Access Compliance Report

Public Rights-of-Way

Intersection ID: 2499	Main Street: LAGRANDE_DR	Cross Street: HIGHLAND_CREEK_PY	Location: SW
ADA ID: 0E828472ACF6	Ramp Type: PerpDiag	Initial Pass/Fail: Fail	Overall Compliance: No
			Severity Score: 21.25

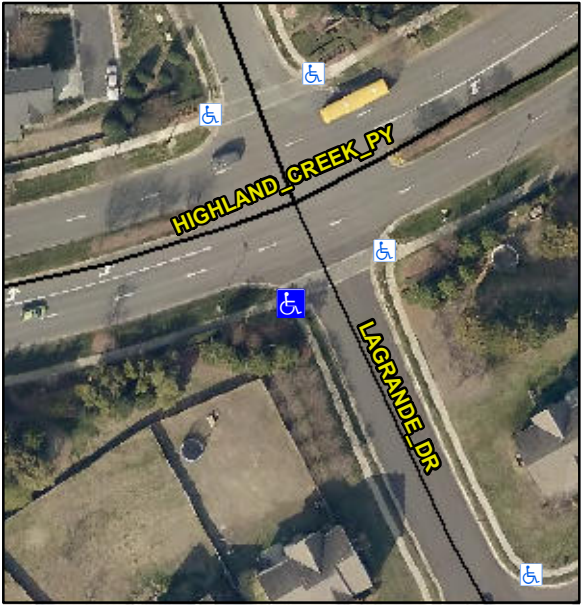
Codes/Mitigation Info/Possible Solution			Field Measurements/Component Compliance		
	Possible Solutions:		Compliance	Description	Data
	Remove & Replace Curb Ramp With Two New Directional Ramps or Equivalent.		No	Ramp Length (in)	56.0
			No	Ramp Width (in)	46.0
			N/A	Flare Type LT	N/A
			N/A	Flare Slope LT (%)	N/A
			N/A	Flare Traversable LT?	N/A
			N/A	Landing Length (in)	N/A
			N/A	Landing Width (in)	N/A
			N/A	Landing Slope (%)	N/A
			N/A	Landing X Slope (%)	N/A
			N/A	Landing Curb? (Y/N)	N/A
			N/A	Shared Landing?	N/A
			N/A	Gutter Ponding?	N/A
			N/A	Gutter Lip Ht (in)	N/A
			N/A	Painted X Walk1?	Yes
			N/A	X Walk 1 Direction	To E
			N/A	X Walk 1 Width (in)	98.0
			N/A	X Walk 1 Slope (%)	4.1
			N/A	X Walk 1 X Slope (%)	4.7
			N/A	Ramp inside XWalk1?	Yes
<p>Surveyor Notes:</p> <p>N/A</p> <p>PROW/ADA:</p> <p>R304.5.1, R304.2.2</p>			N/A	Flare Type RT	N/A
			N/A	Flare Slope RT (%)	N/A
			N/A	Flare Traversable RT?	N/A
